OFF-SITE DOSE CALCULATION MANUAL CHANGES

Doc No.: PMP-6010-OSD-001
Title: OFF-SITE DOSE CALCULATION
MANUAL

Rev 026
No.:

INDIANA MICHIGAN POWER	PMP-6010-OSD-001	Rev. 26	Page 1 of 98
OFF-SITE DOSE CALCULATION MANUAL			
Information			
Erik Merchant Writer	Environmental Manager Document Owner	Environmental Cognizant Organization

Information	PMP-6010-OSD-001	Rev. 26	Page 98 of 98
OFF-SITE DOSE CALCULATION MANUAL			
Attachment 3.23	Off-Site Monitoring Locations - REMP		Page: 98

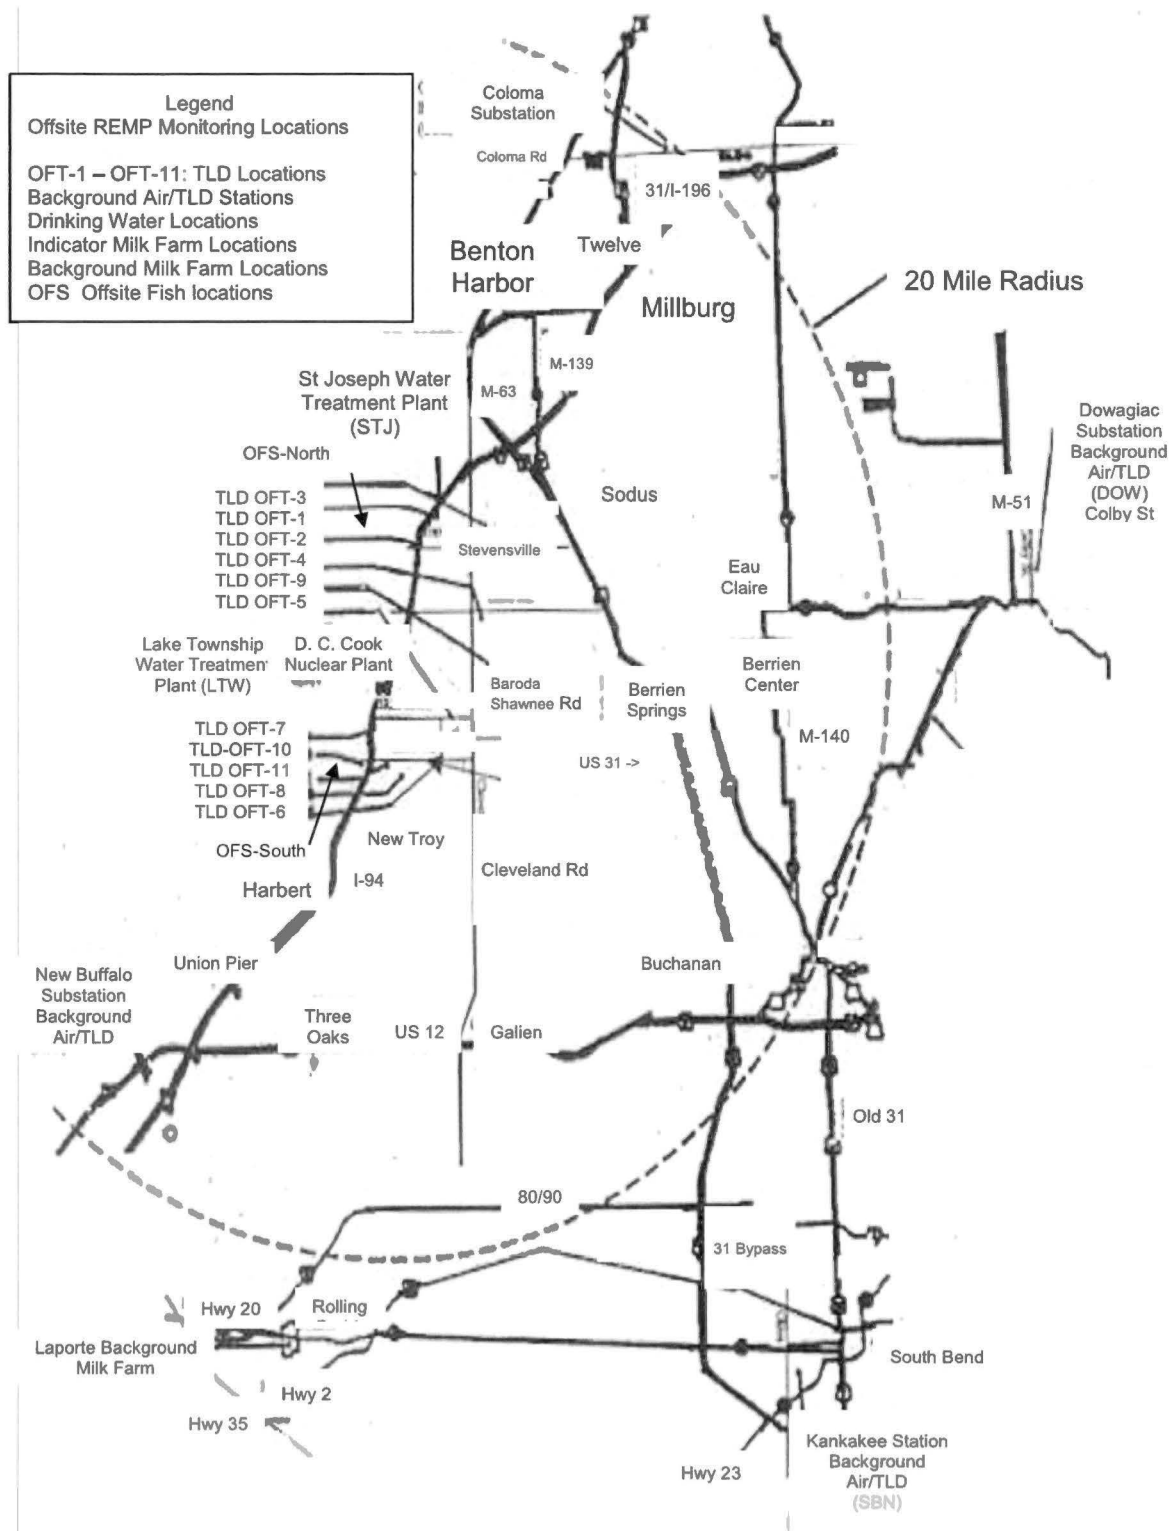
Page 33, Step 3.3.2 b.1, should read vent stack noble gas channels to consistent with step 3.3.2 c.1 on page 34. Ensure the Att. 3.23 Map copies correctly
Comments provided to the procedure writer.
